ENCLOSURE 2

MFN 11-245

Response to NRC RAIs - NEDE-33284P, Supplement 1,
Marathon-Ultra Control Rod Assembly

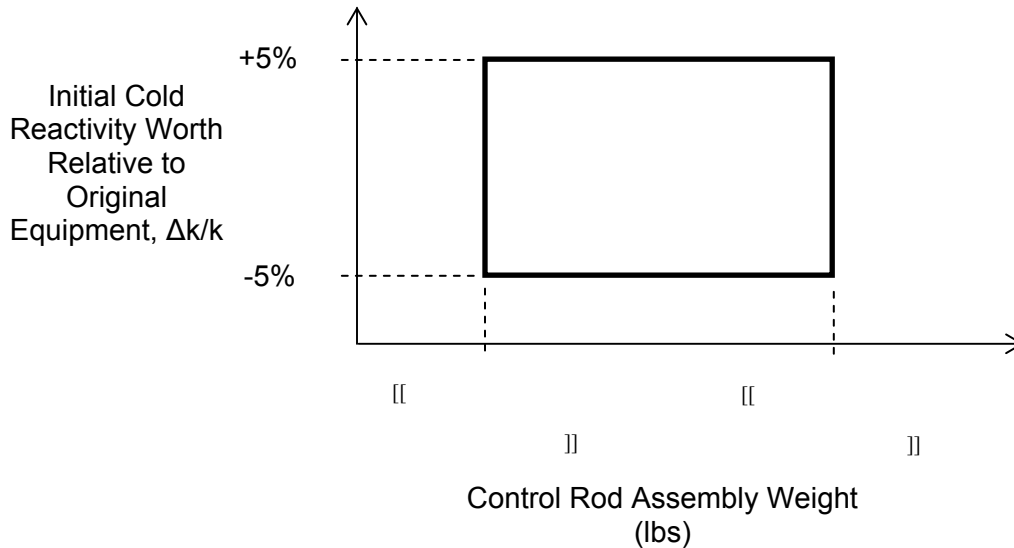
- Confirm that the potential impact of weight differences between alternate absorber loading patterns is being addressed in the mechanical design calculations and identify the limiting loading pattern. Discuss the maximum possible control rod weights and how they compare to the loads used in the current lifting load finite element models.

- The NRC staff is considering imposing a letter notification requirement, similar to the GESTAR-II process, on any Marathon-Ultra control blade design with an alternative absorber loading pattern. The notification would provide detailed specifications of the alternate absorber loading pattern for each lattice configuration, document the acceptance criteria used to judge its performance, and confirm compliance with these criteria. Discuss the use of a notification process for future design alterations.

- In summary, the following figure summarizes permissible design space. The vertical axis of the design space is the primary nuclear requirement of matched initial reactivity worth as discussed in Section 4.4 of NEDE-33284P Supplement 1. The horizontal axis of the design space is the mechanical requirement of overall control rod weight, defined by the weight limits shown in Table 2-1 of NEDE-33284P Supplement 1.
